September 6, 2022

Subject: Sudbury-Hudson Transmission Reliability and Massachusetts Central Rail Trail Project (DEP File # 301-1287) OOC Issued 02/04/2021 Notification of Minor Change and Request for Administrative Approval

Attached please find three plan sheets showing the proposed minor change that upon administrative approval would replace the corresponding sheets in the plan set previously approved by the Commission.

PLAN 63 OF 349

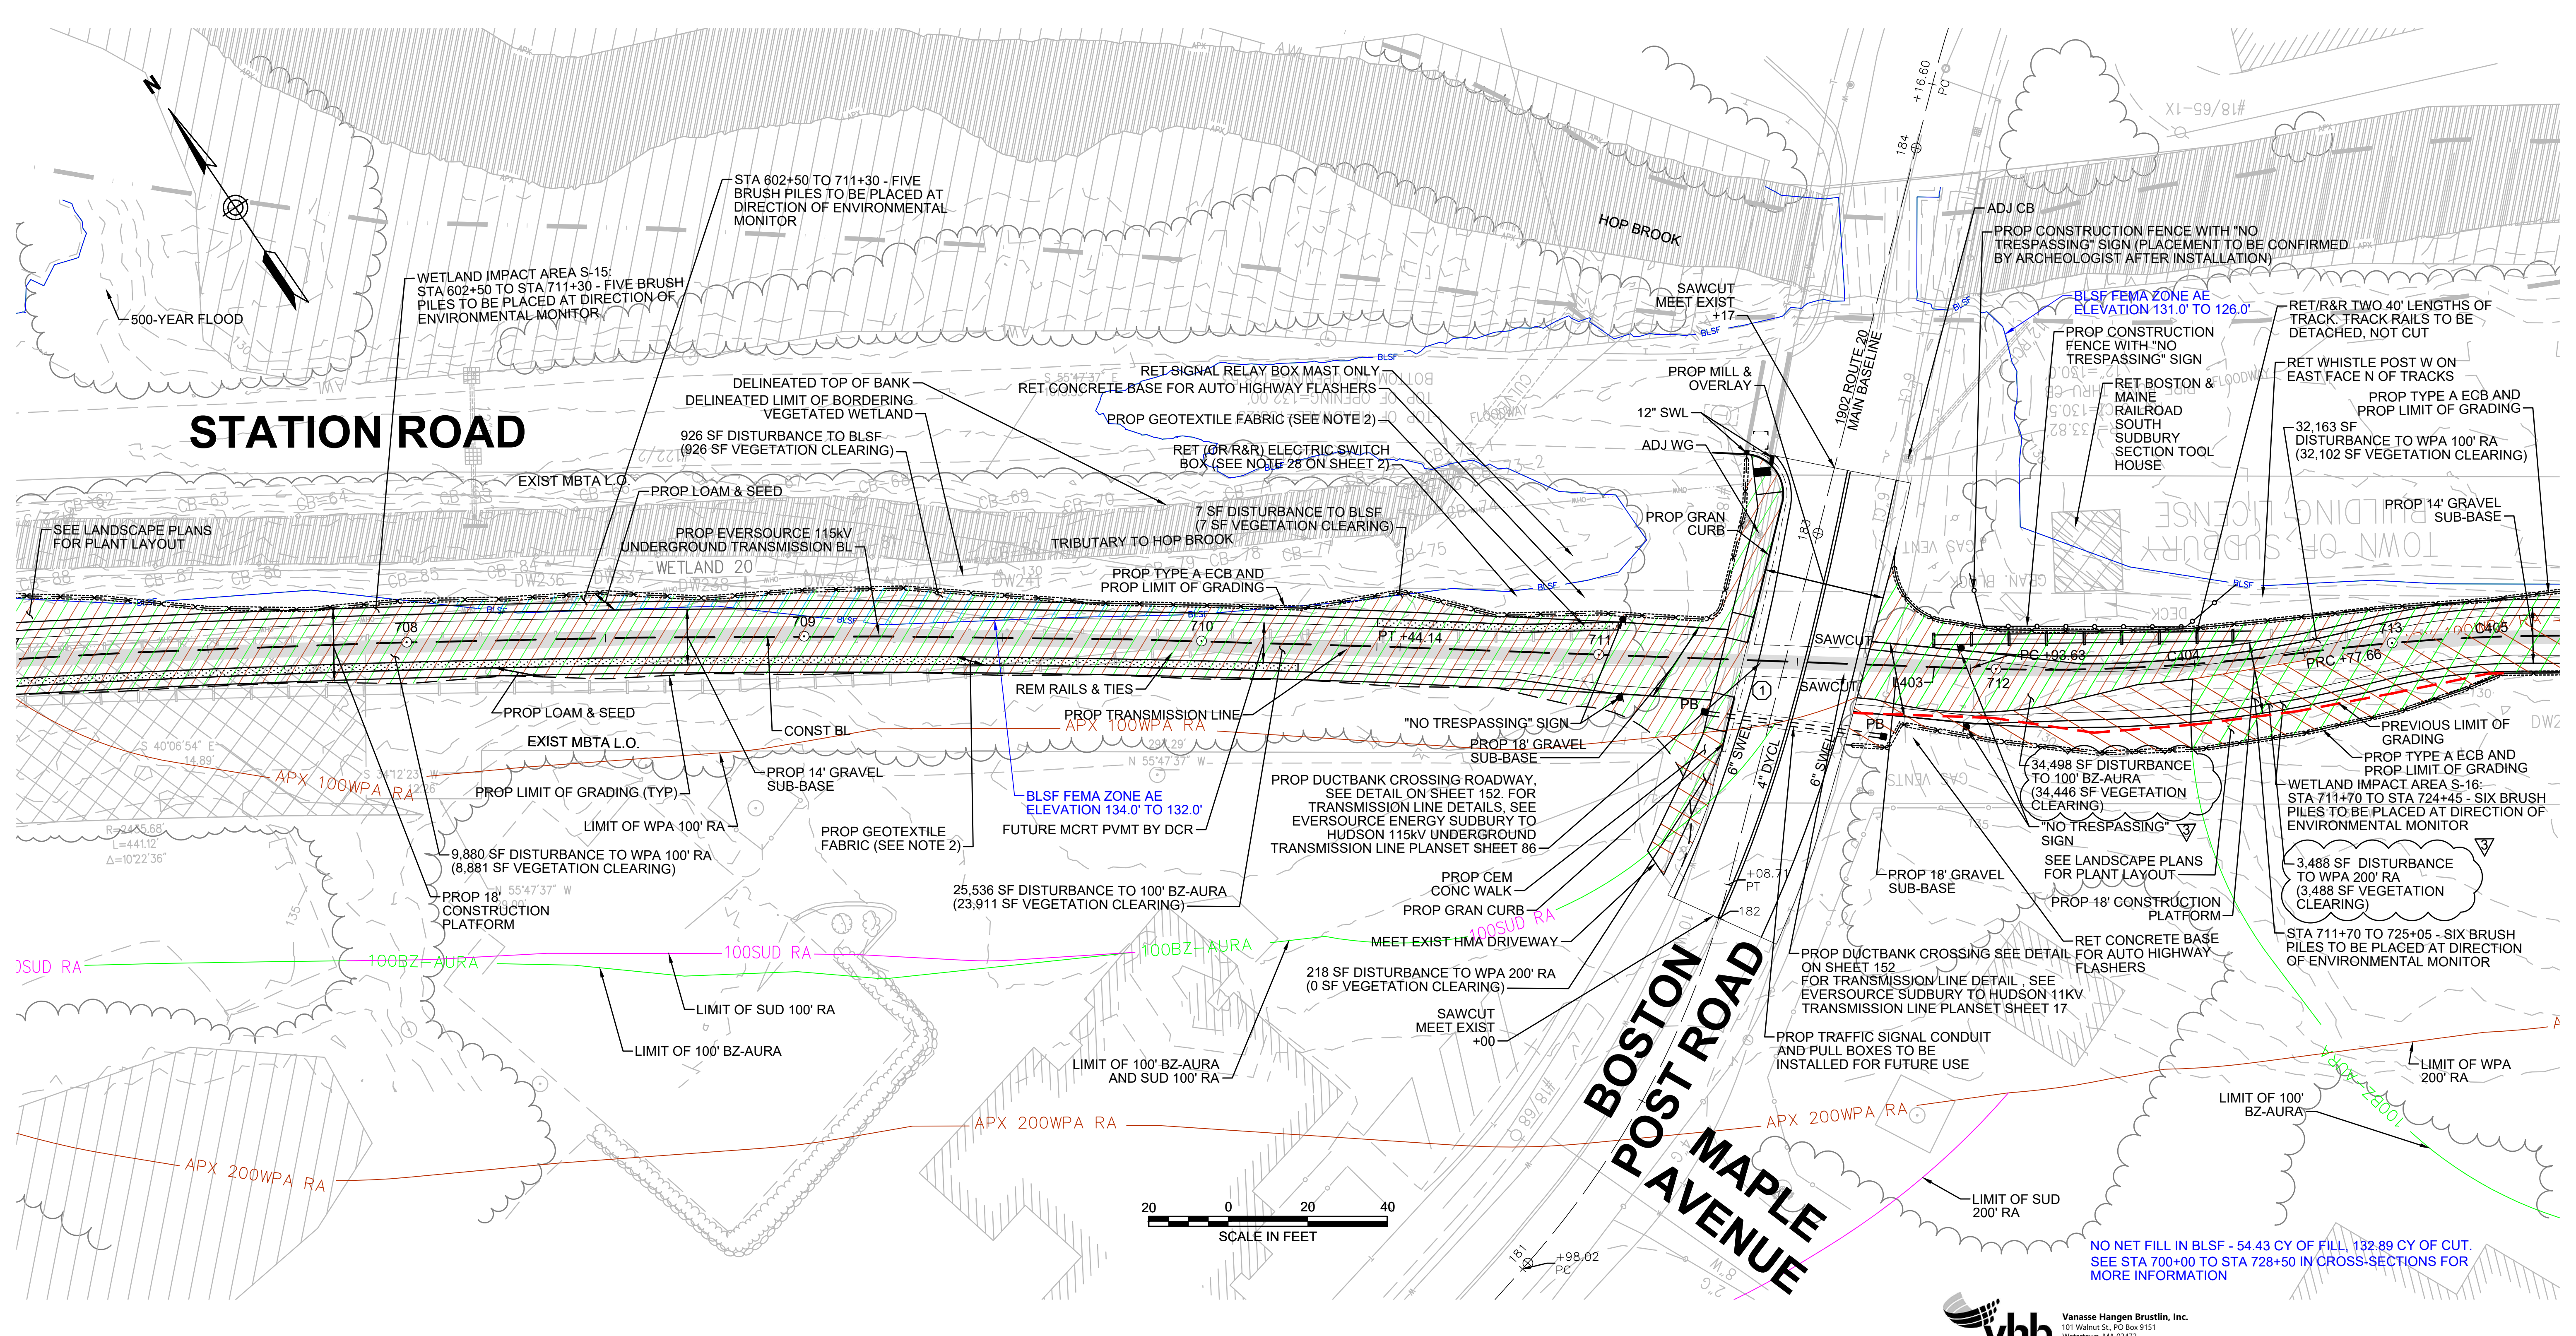
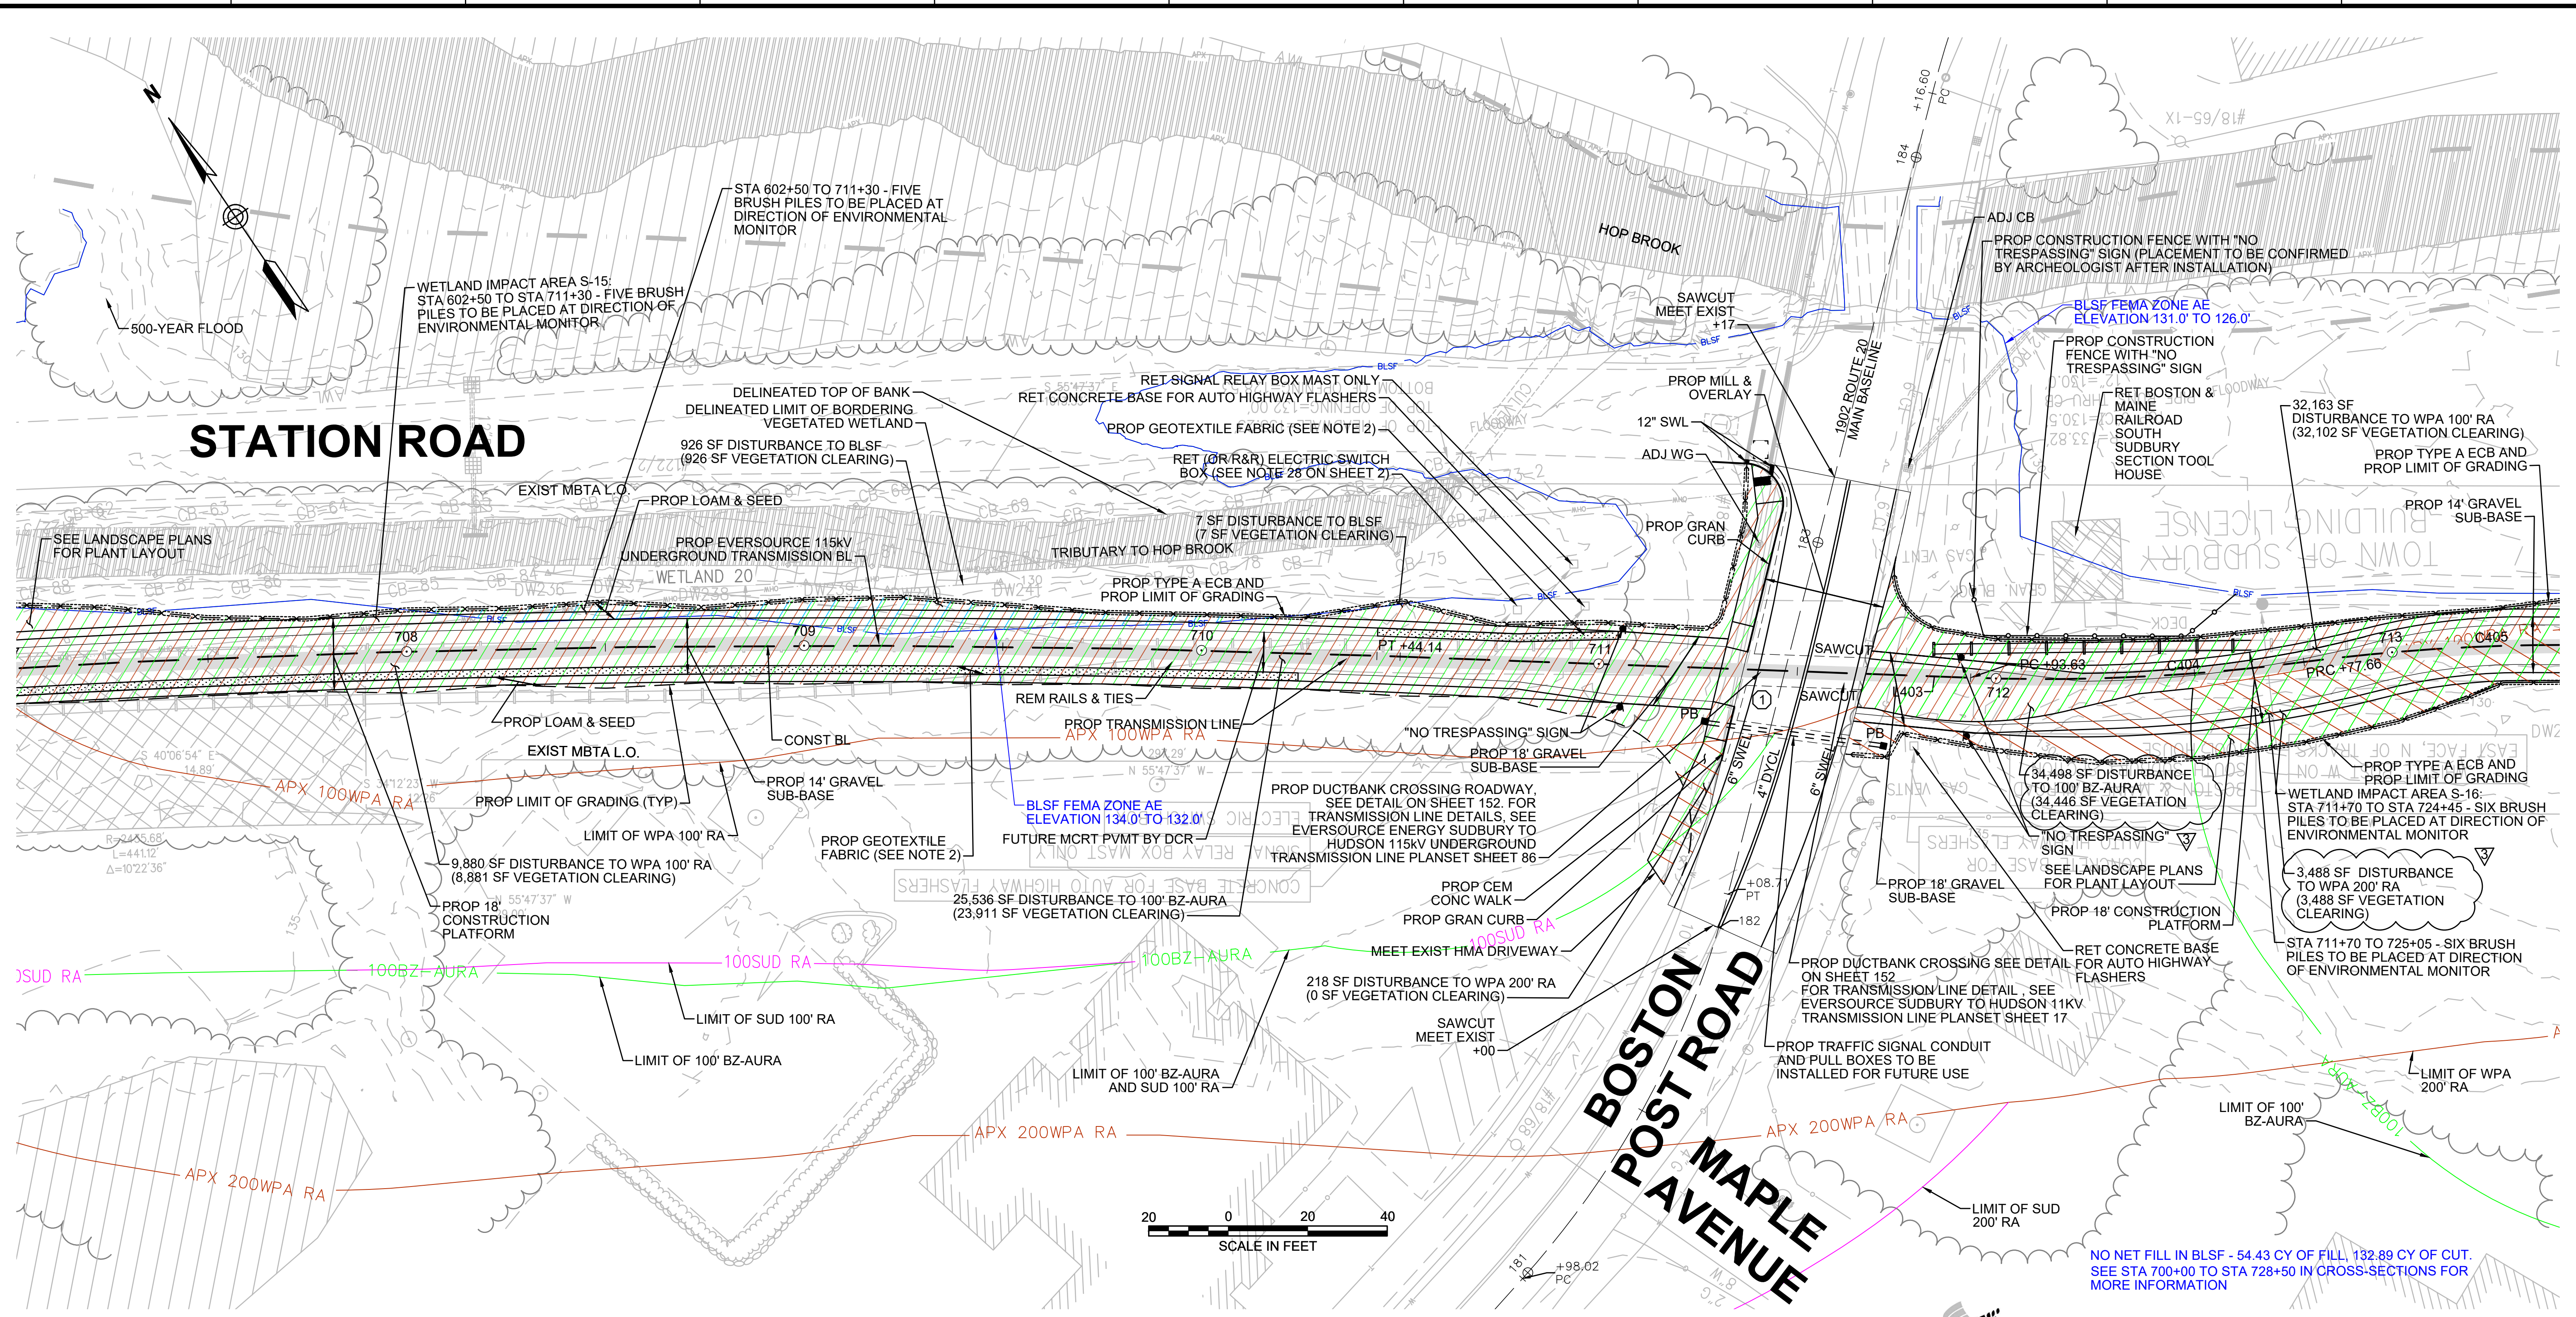
As background, Eversource and DCR recently appeared before the Sudbury Historic District Commission to obtain a Certificate of Appropriateness (COA) for proposed work within the George Pitts Tavern Historic District. The COA issued on 08/04/22 requires that the Project remove and reset (or retain if possible) existing rail tracks in front of the Boston & Maine Railroad Section Tool House, located just east of Boston Post Road (Route 20). To accomplish this, the Project alignment (i.e., the proposed limit of work) has been expanded slightly southward at this location, resulting in a minor increase to the Project's footprint within the 200-Foot Riverfront Area and within the 100-Foot Buffer Zone ("BZ")/Adjacent Upland Resource Area ("AURA") of a vegetated wetland. The only proposed change occurs within approximately 160 linear feet of the rail trail alignment and associated grading. There are no changes to the proposed location of the underground electrical transmission line.

The proposed minor change would result in an increase of 847 square feet to the overall Project footprint in this area. All of this 847 square feet is within the 200-foot Riverfront Area of Hop Brook (all within outer riparian zone) and 379 square feet of this area is within 100-Foot BZ/AURA. This 847 square feet area is currently forested and as shown on the

N.O.	DESCRIPTION	BY	DATE	APPR.
3	PATH REALIGNMENT 710+50 TO 713+50		08/19/2022

PLAN 64 OF 349

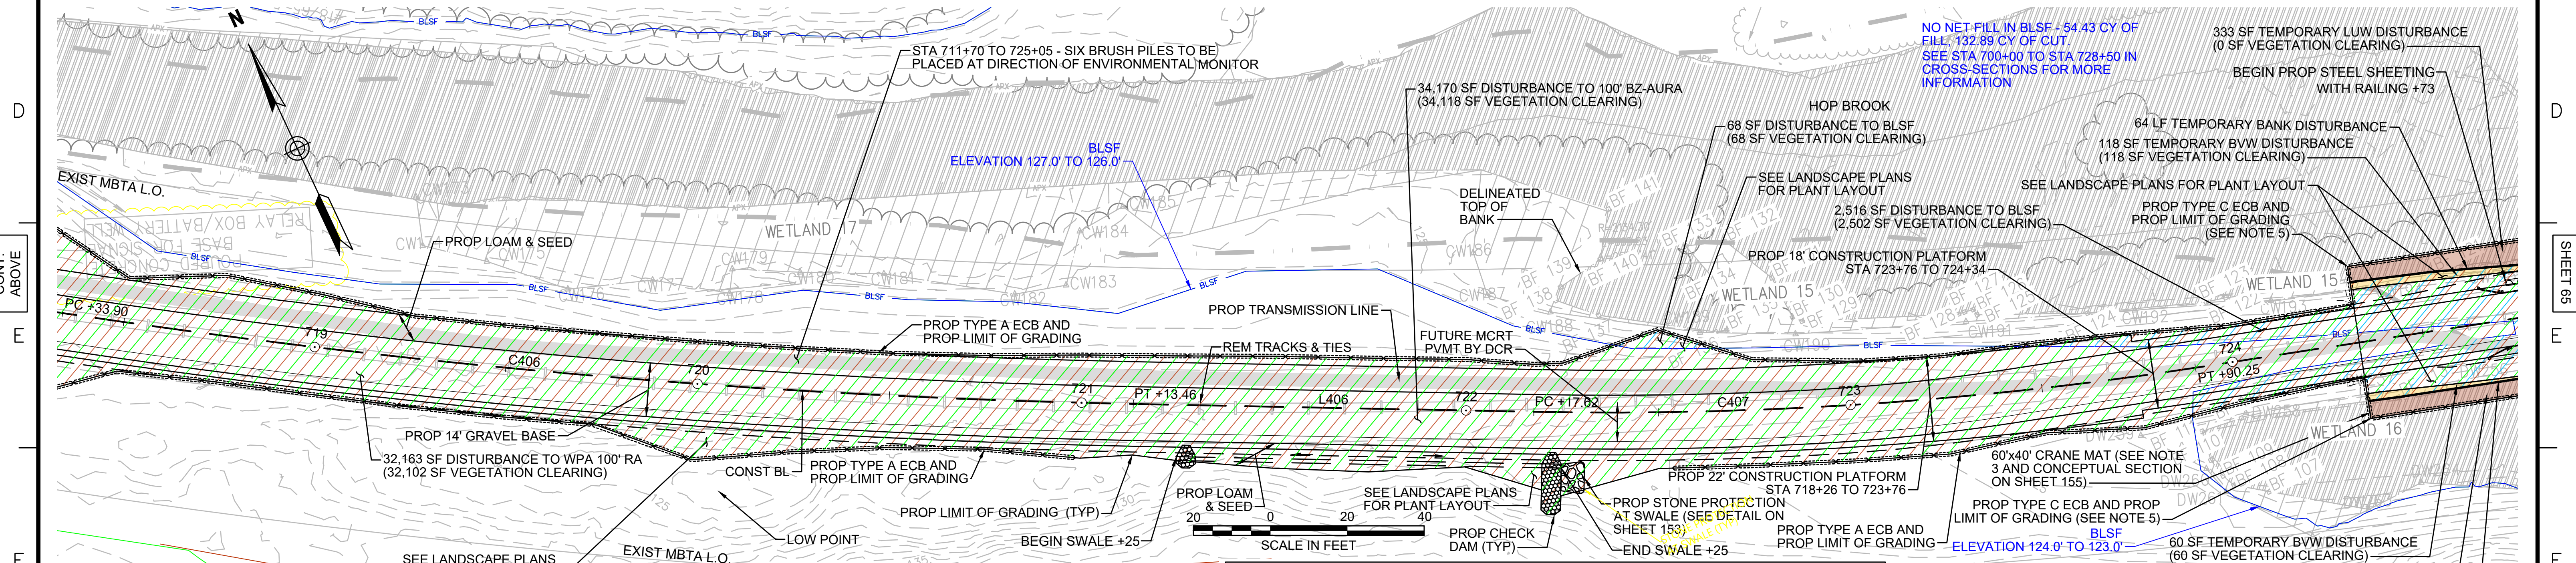
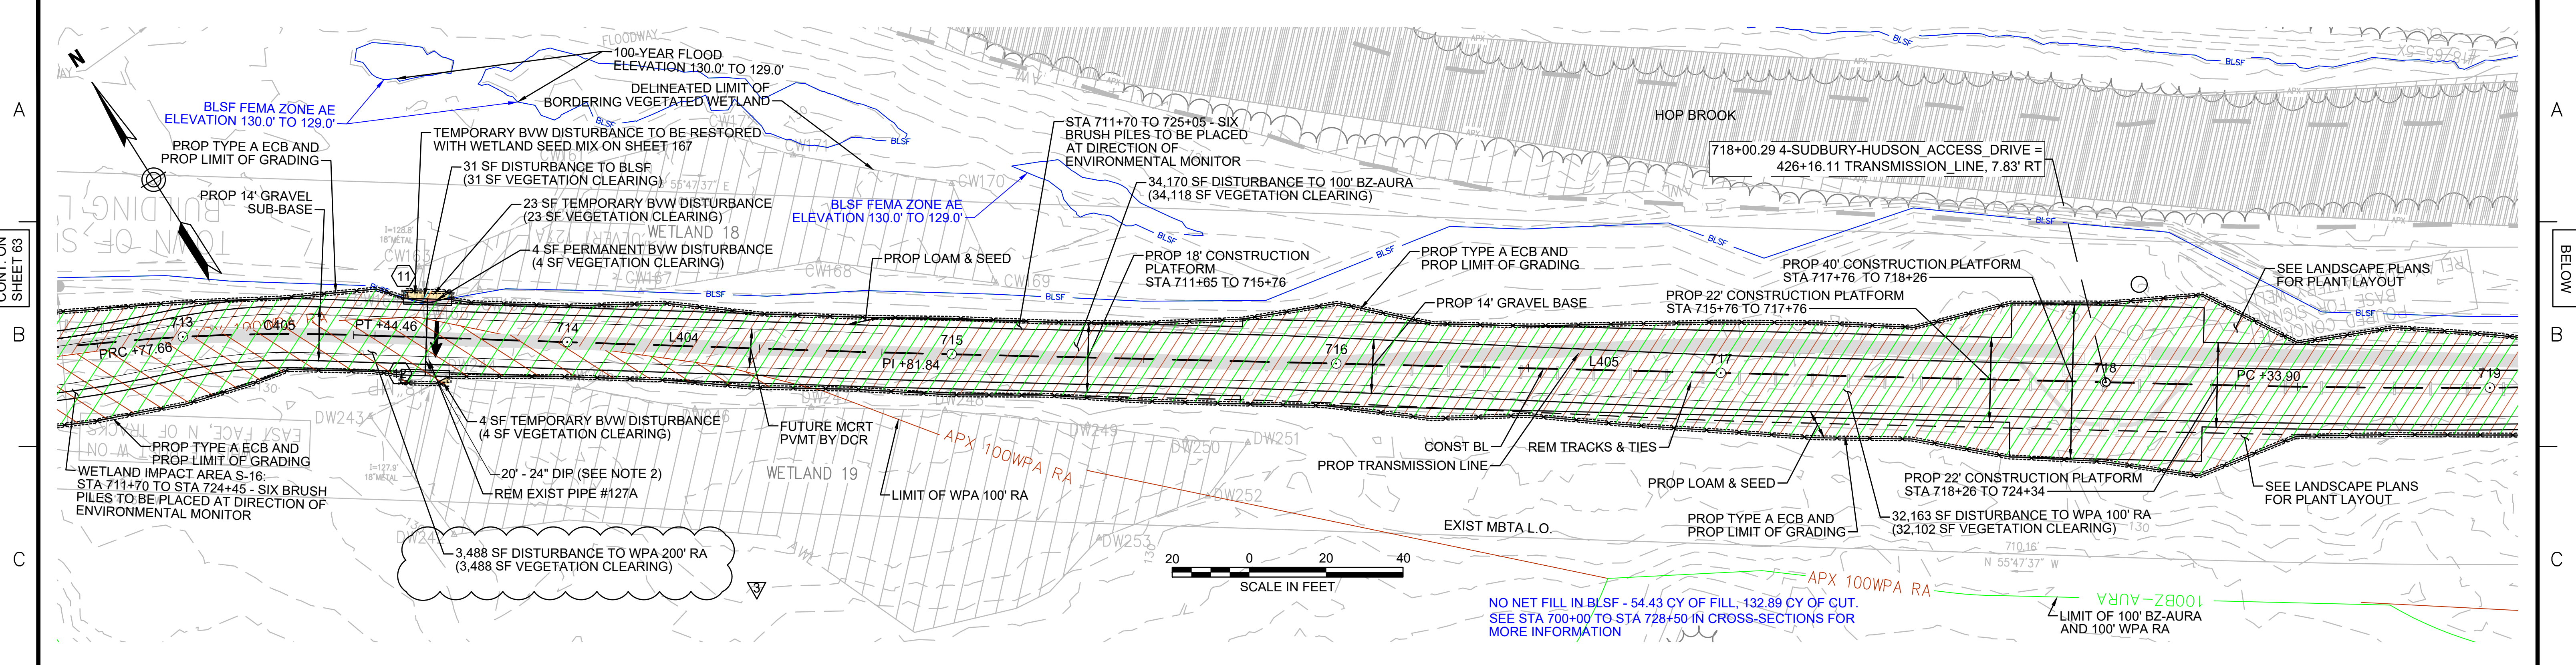
The 160-foot section of realigned bike path does not result in an increase to the approved impervious surfaces from the Project and because it occurs within only 160 feet of the path, the change amounts to a *de minimis* change in stormwater flows. With the minor realignment of 160 feet of the rail trail, stormwater from this section will be directed southward between stations 712+00 and 713+50. This takes advantage of an existing low area south of the rail bed, and ultimately results in a longer path of travel for stormwater, providing increased opportunity for infiltration and recharge before reaching the culvert at station 713+63.

NO.	DESCRIPTION	BY	DATE	APPR.
3	PATH REALIGNMENT 710+50 TO 713+50		08/19/2022
